June 2, 2014

**Re: Rosemont Copper Mitigation Preferences**

# Cienega Watershed: Potential State Lands Acquisitions

## PIMA COUNTY DISCUSSION ITEMS

ATTACHMENT 1

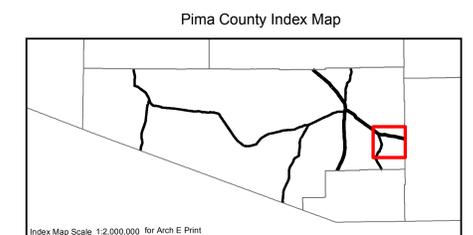
Attachment 1 shows each of the priority mitigation areas and their relationship or adjacency to existing conservation efforts of the County.

Our priority would first be the Lower Cienega Creek acquisition of 4,885 acres, followed by Davidson Canyon at 2,739 acres; then the Santa Rita linkage, followed by the Whetstone Riparian Additions.

Objection Figure 1  
February, 2014

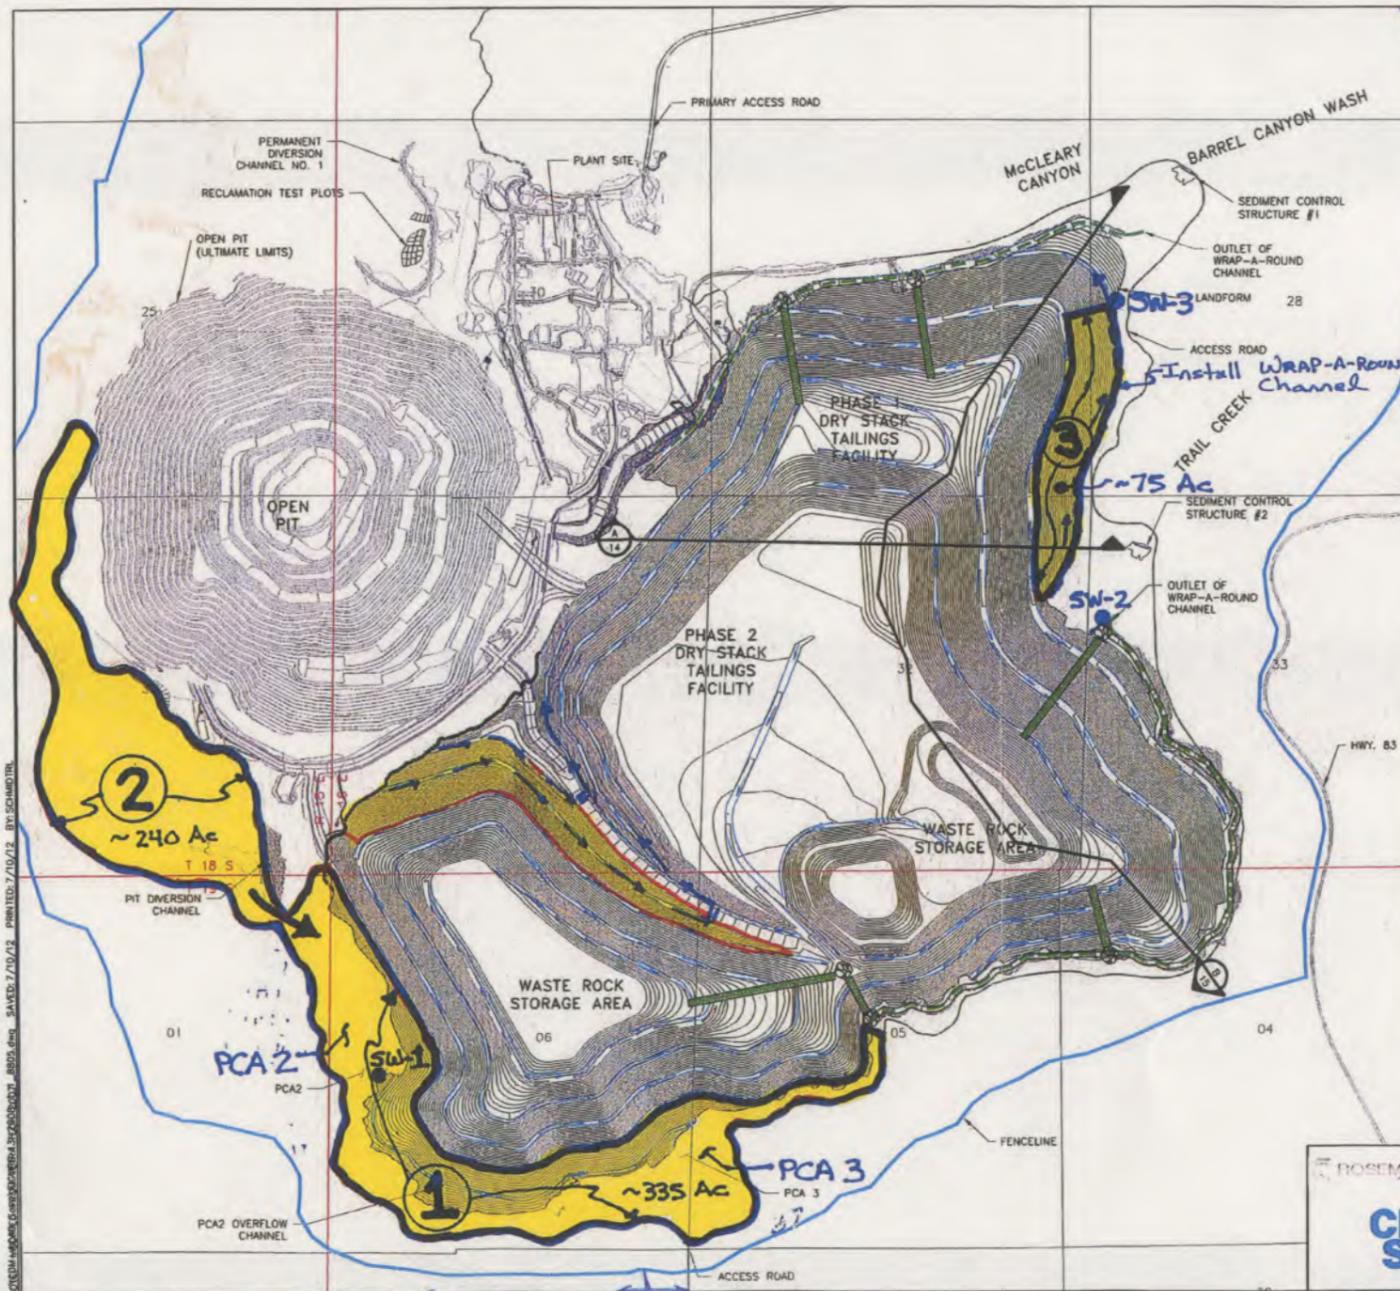
10. Release surface water into Trail Canyon from western and southern portion of the mine site, and allow runoff from northeastern tailings mound into Barrel Canyon (Mark) Modify the site water management plan to reduce impacts.
